From:	Karin Nosrati, DC <bforback@gmail.com></bforback@gmail.com>
Sent:	Wednesday, November 20, 2024 7:07 PM
То:	Carey Certo
Subject:	Fwd: Re-submission as .pdf - same content
Attachments:	SEPA comments final 03-06-2024 5pm.pdf

My comments to the SEPA for the proposed gas station, convenience store and car wash address the following items: Please see the attached file entitled "SEPA comments final 03-06-2024 5pm"

SEPA comments:

1. Earth

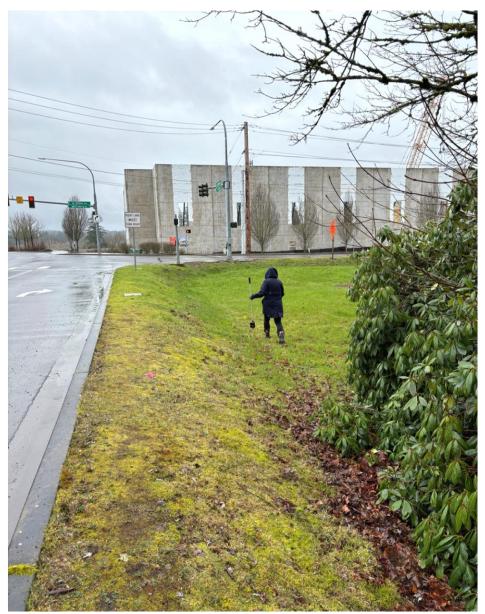
This project would need to bring in soil, if the concrete surfaces are intended to be level. Sloped toward the east and at eastern most portion 4-5' below street level. Also sloped toward the southwest and west portion.
